# Relocation of Wire on Replacement VFDs

TSB 2012009

## TECHNICAL SERVICE BULLETIN

**Old Model VFD**  
White/Cream color with hinged cover  
Front View

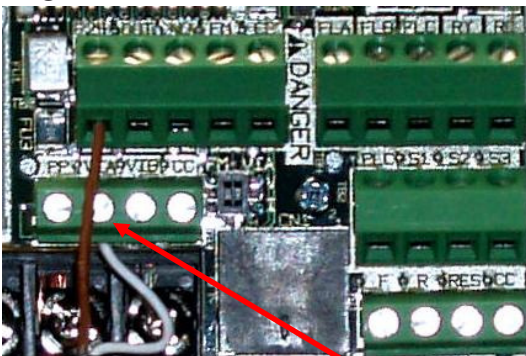
Better Water LLC's part number of **EQMOBO01353** which is the "**3 Phase-In / 3 Phase-Out / 3 Horsepower VFD**" will remain the same. The difference between these two models is mostly cosmetic. See the pictures below of the old and new models.

**Old Model VFD**  
White wire is located on the **VIA**  
terminal post

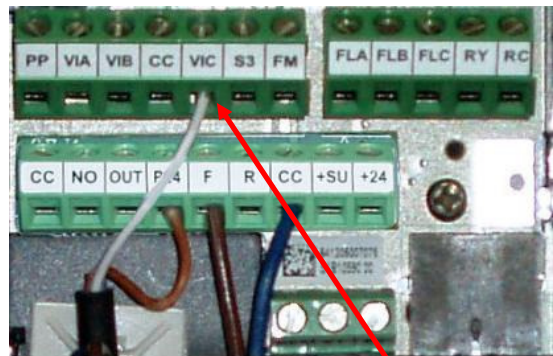
1. Take note of the location of the white wire (*from the pressure transducer*) on the older model VFD's terminal post labeled **VIA**.
2. Replace the older model VFD with the newer model VFD.
3. On the newer model VFD, relocate the white wire (*from the pressure transducer*) to the terminal post labeled **VIC**.

**New Model VFD**  
White wire is located on the **VIC**  
terminal post
